DESIGN ADVISORY BOARD Tuesday, January 13, 2015 Conference Room 12, City Hall, Burlington, VT

15-0704CA: 61 SUMMIT ST (I, Ward 6) University of Vermont

MEMORANDUM

To: The Design Advisory Board
From: Mary O'Neil, AICP, Senior Planner
RE: ZP 15-0704CA/CU; 61 Summit Street
Date: January 13, 2015

C-1.1

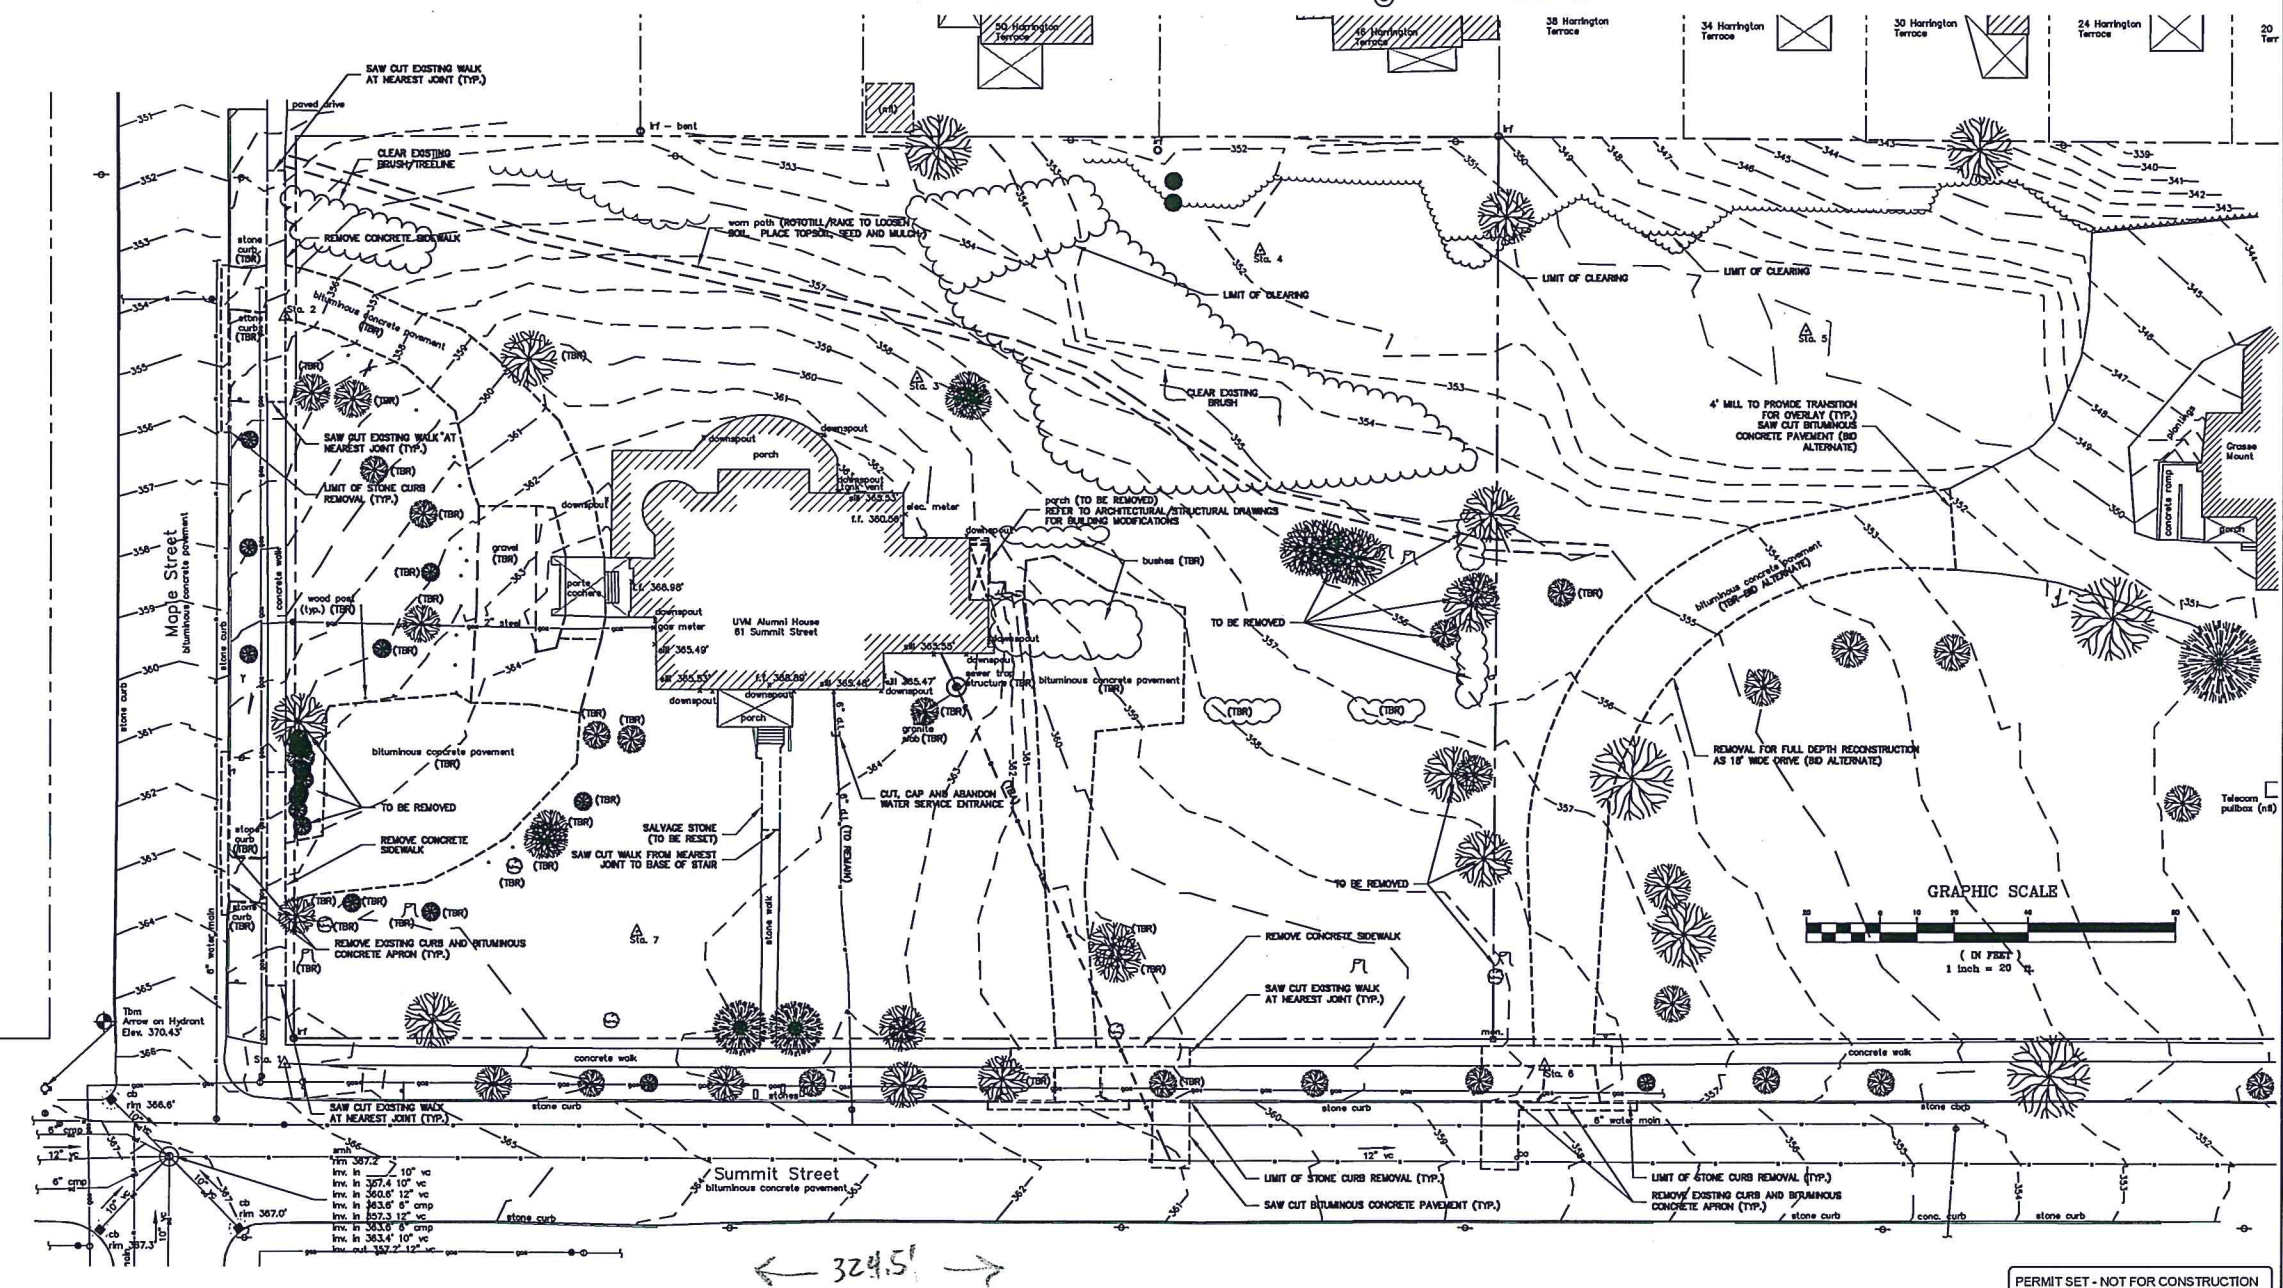
The site falls gradually away to the west, with a collection of large trees both to the west and north. Plan C1.1 defines “clearing existing brush”, however that area has plantings that are so large as to escape definition as brush. No specimen trees are identified on the plan.

Plan C-1.1 notes “clear existing brush”, which appears to be much larger growth than suggested. The City Arborist has been contacted to confirm the characterization of existing growth, and to assure no loss of specimen trees in the area of development.

C-1.3

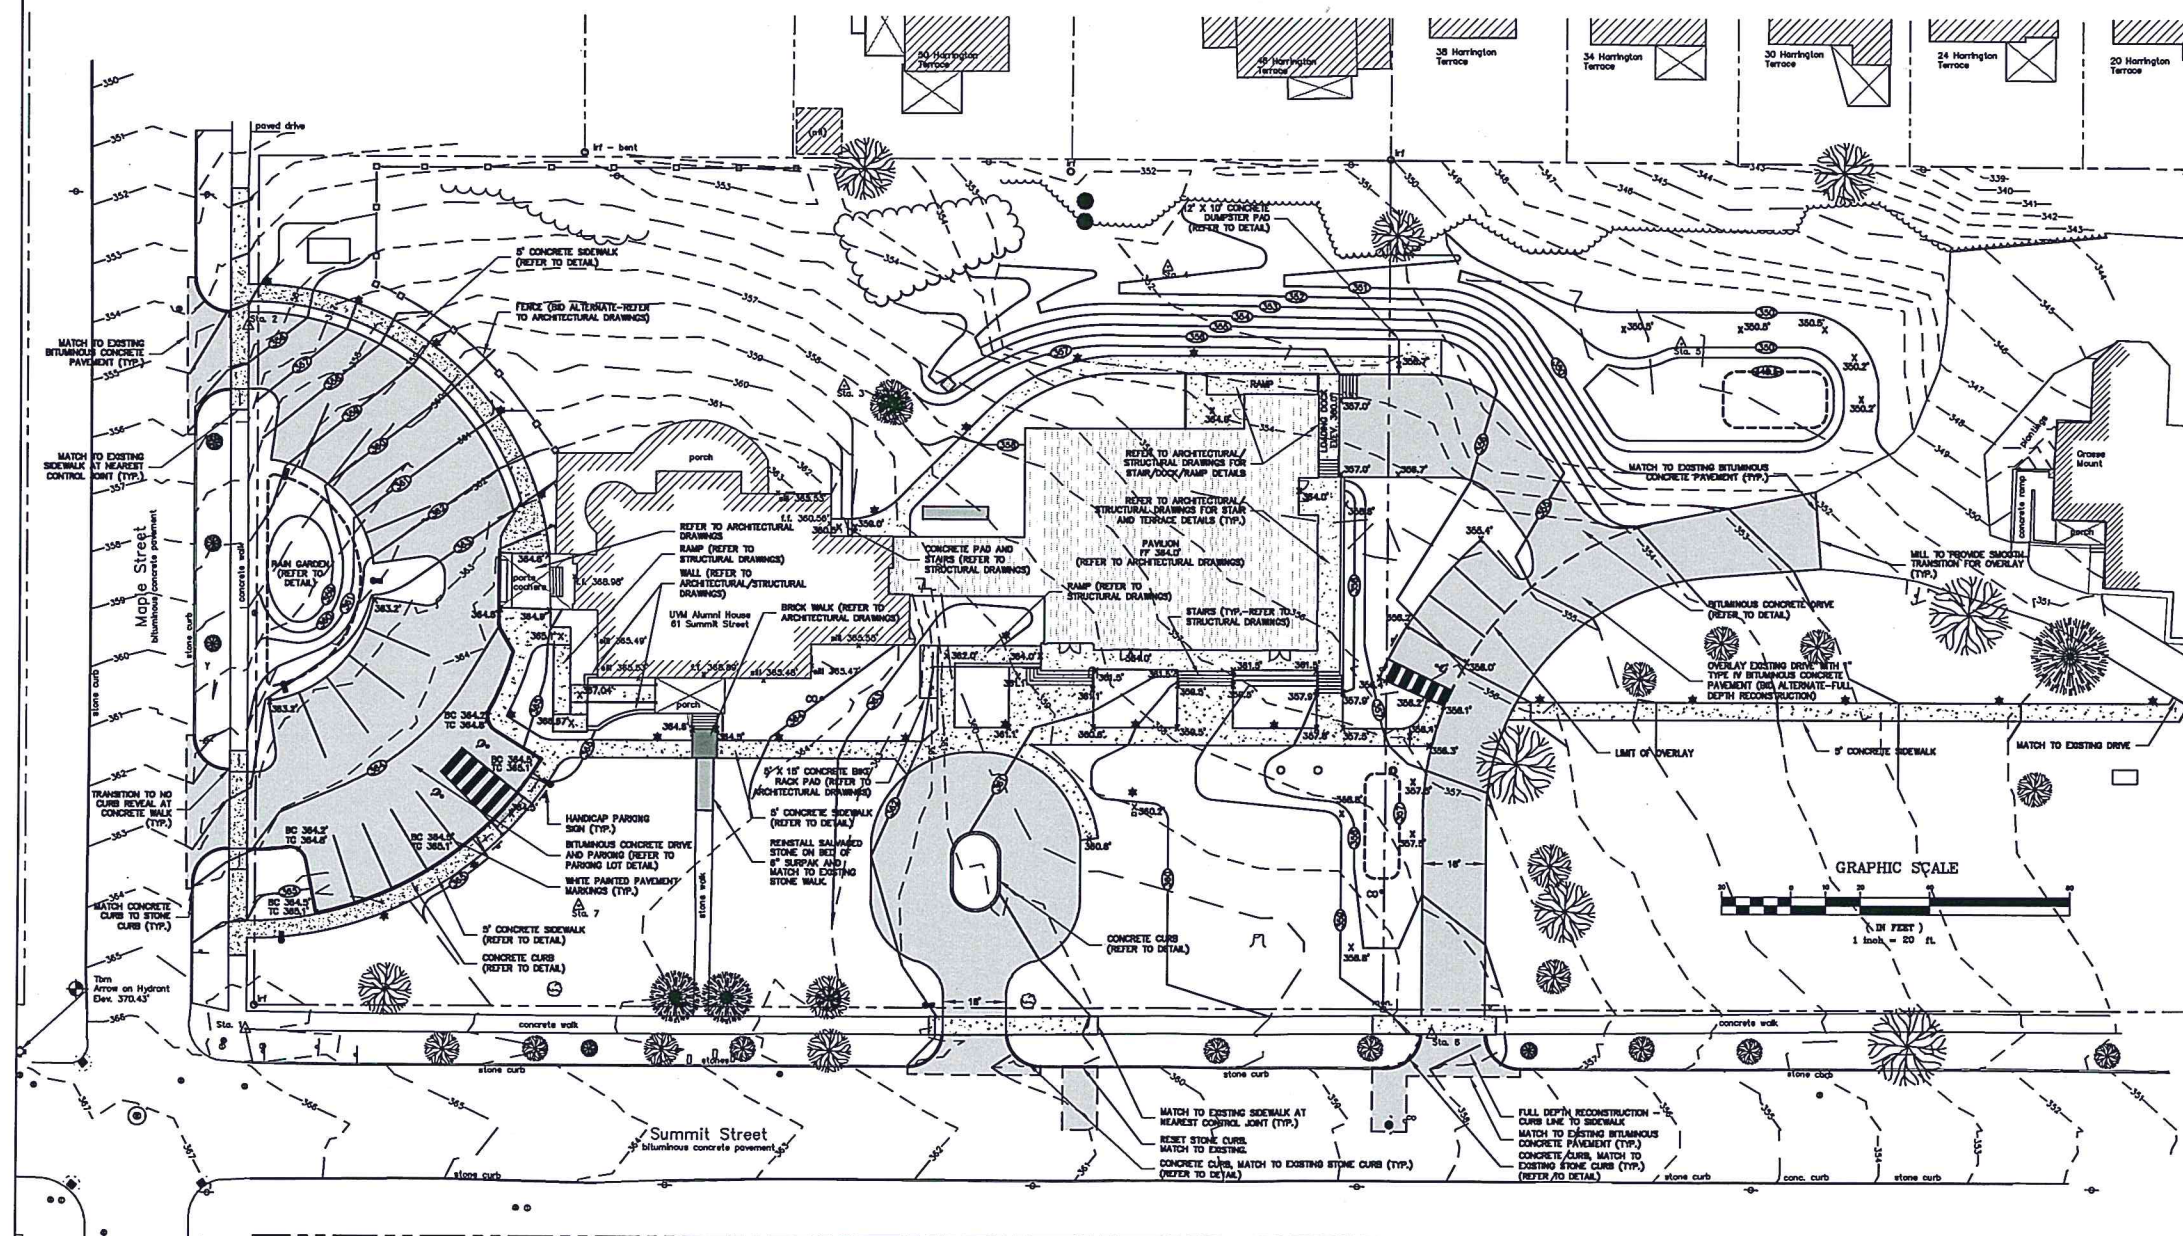
Runoff during the 0.9-inch storm will be retained within a new oversized concrete vault and then be released at a controlled rate to the City's existing Combined Sewer System (CSO). In addition, runoff from other impervious areas of the site will be retained and infiltrated into three new bio-retention planting areas surrounding the new and existing buildings. See C-1.3 for more details.

5 Boundry Fence Detail (Bid Alternate)

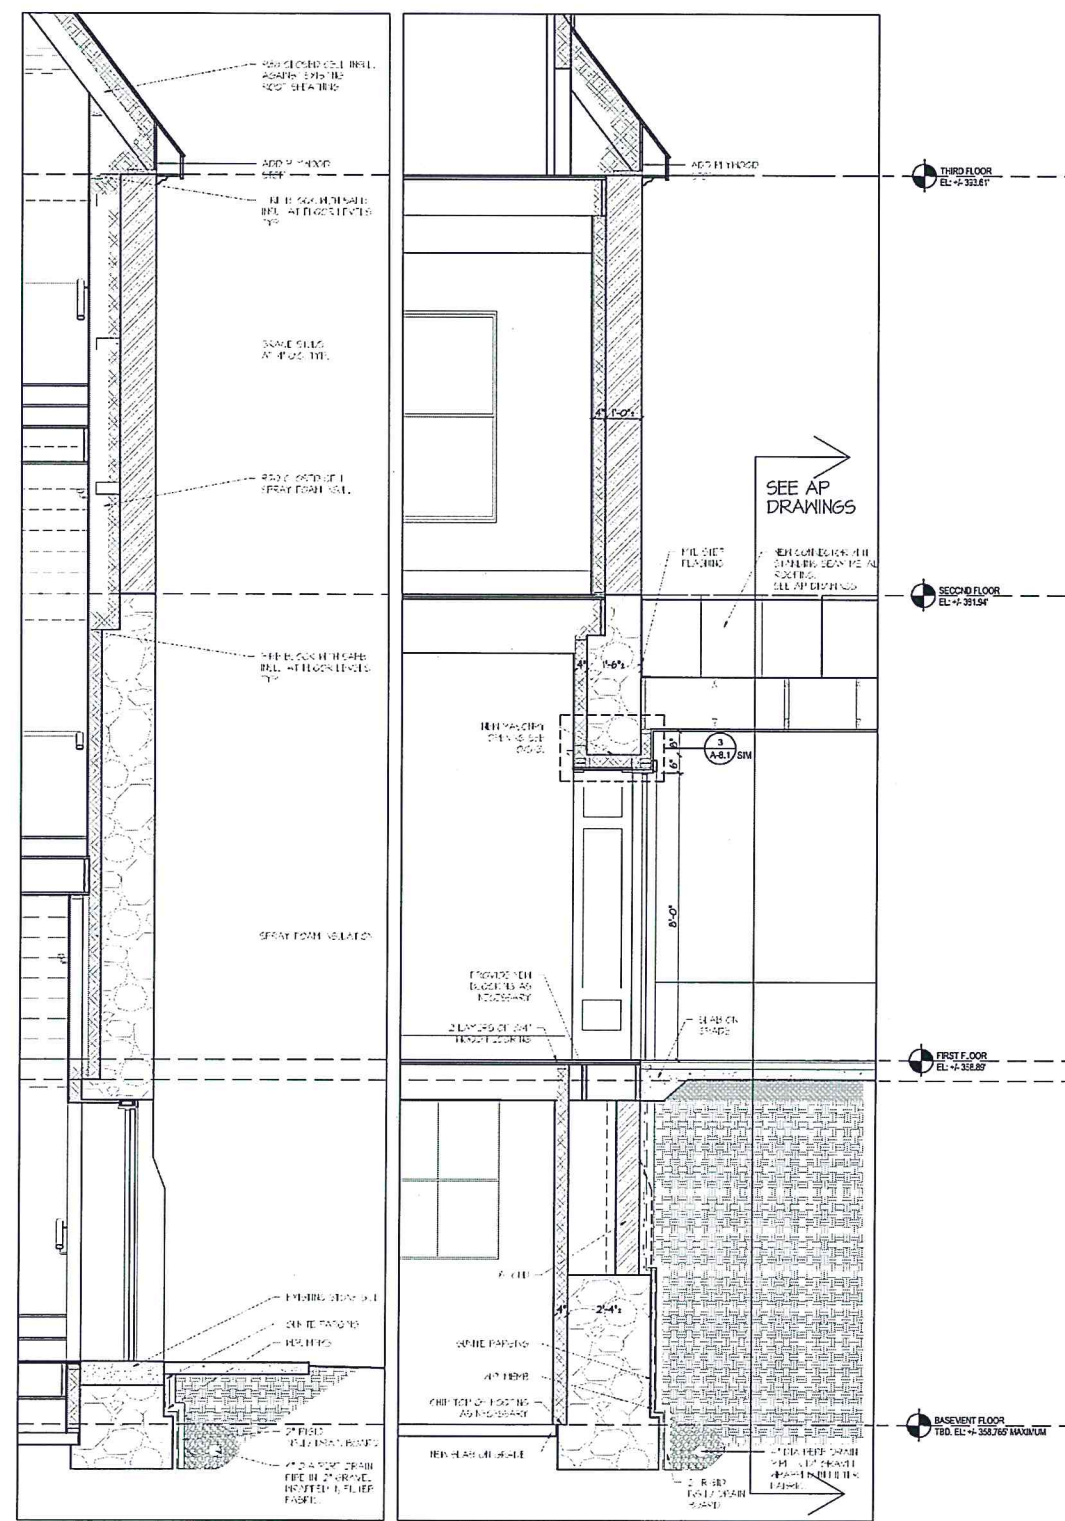
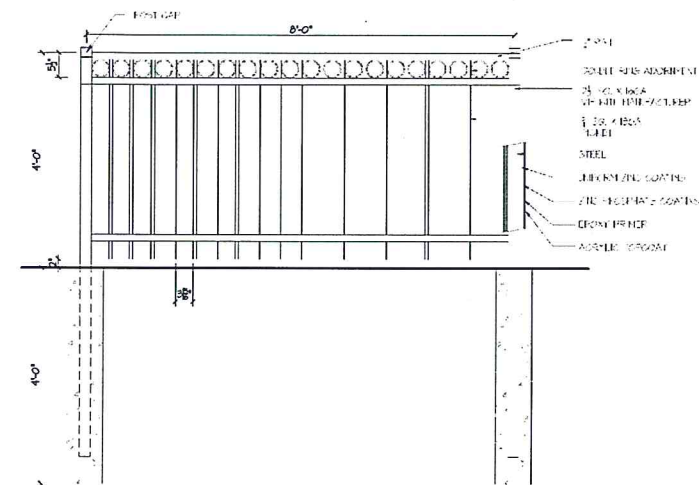
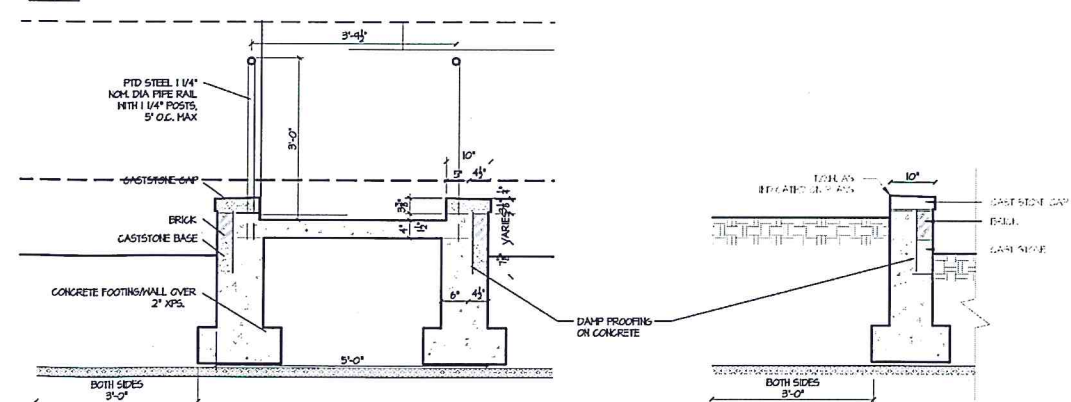
A 4' fence is illustrated on the southwest of the parcel; presumably to ban pedestrian foot traffic in the existing pattern of use. See Plan A6.5 for detail drawing.
